December 12, 2023

Re: **Storage Facility**
Project #: PR-2020-004645
Application #: SI-2023-01803

Please find the following responses addressing comments received in a letter dated November, 29 2023. In an effort to address your comments concisely and simplify your review of these development plans, we have summarized your comments and our responses below. Your comment is listed first, followed by the response in Bold.

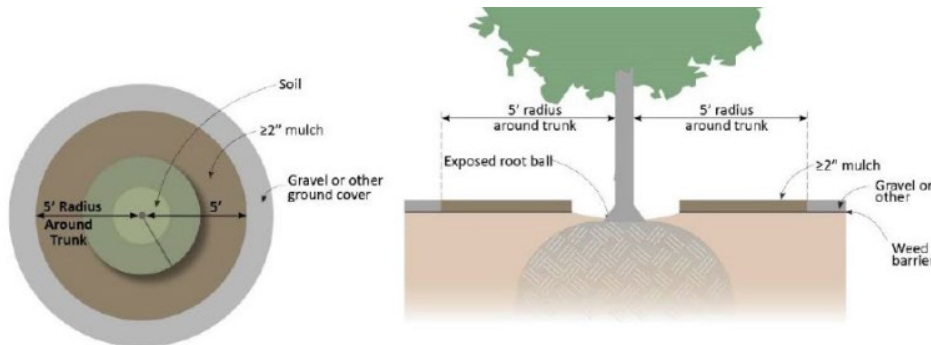
13. 5-6(C)(4)(i) Shade trees planted approximately 25 feet on-center are required along all required pedestrian walkways. If the walkway is less than 25 feet long, at least one tree is required, or, where there is insufficient space for a tree, a trellis of at least 8 feet high for at least 5 feet along the walkway shall be provided.

Show dimensions of spacing between trees on walkway on the east side of Building B.

YL: Tree spacing along pedestrian path east of building B is now shown on LS-01.
